MFN 06-128

**Subject: Response to NRC Request for Additional Information Letter No. 14
Related to ESBWR Design Certification Application – Reactor Vessel
– RAI Numbers 5.3-1 through 5.3-12**

RAI Numbers 5.3-1 through 5.3-12

Figure 5.3-1. Minimum Temperatures Required Versus Reactor Pressure for Hydrotest — Core Not Critical (Representative curve for the ESBWR)

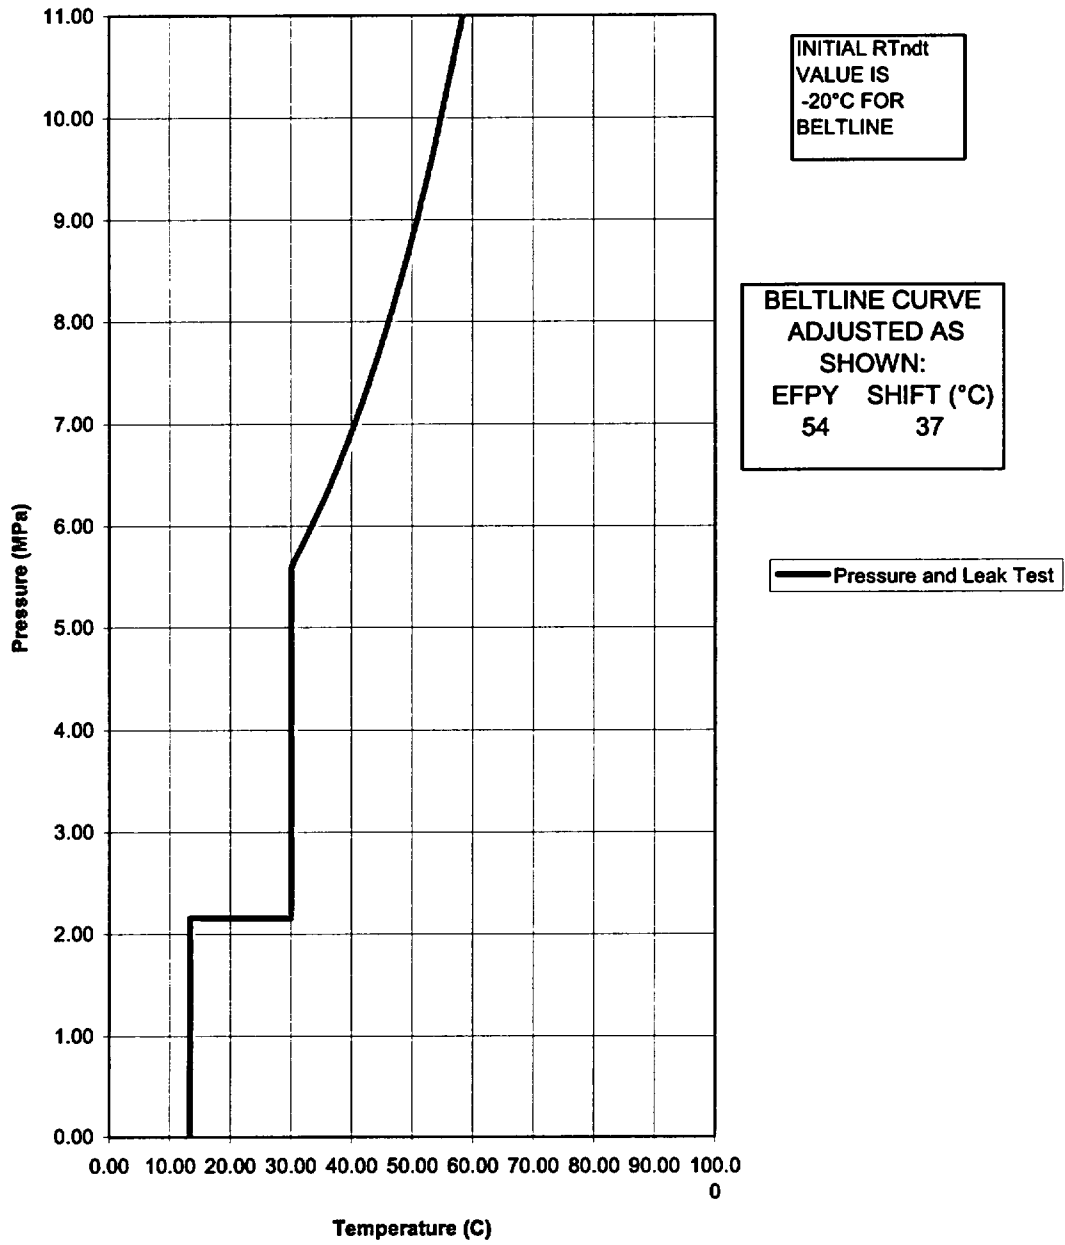
Provide information regarding the derivation of the pressure-temperature (P/T) limit curves provided in the DCD. Identify any deviations from the recommended calculational procedures in Revision 1, July 1981, of Section 5.3.2 of the Standard Review Plan (SRP) and confirm conformance with Appendix G to 10 CFR Part 50.

Clarify the intent of the P/T curves provided in the DCD (e.g., representative or bounding).

The P/T limit curves provided in the DCD are representative of typical BWR P/T curves.

The pressure/temperature limit curves in Figures 5.3-1 and 5.3-2 **are representative for the ESBWR. They** are based on the requirements of 10 CFR 50 Appendix G and Regulatory Guide 1.99.

Representative Pressure versus temperature limits for pre-service and in-service tests when the core is not critical are shown in Figure 5.3-1. Pressure/temperature curves using plant specific data such as materials, fluences and stresses will be developed prior to plant hydrostatic test.
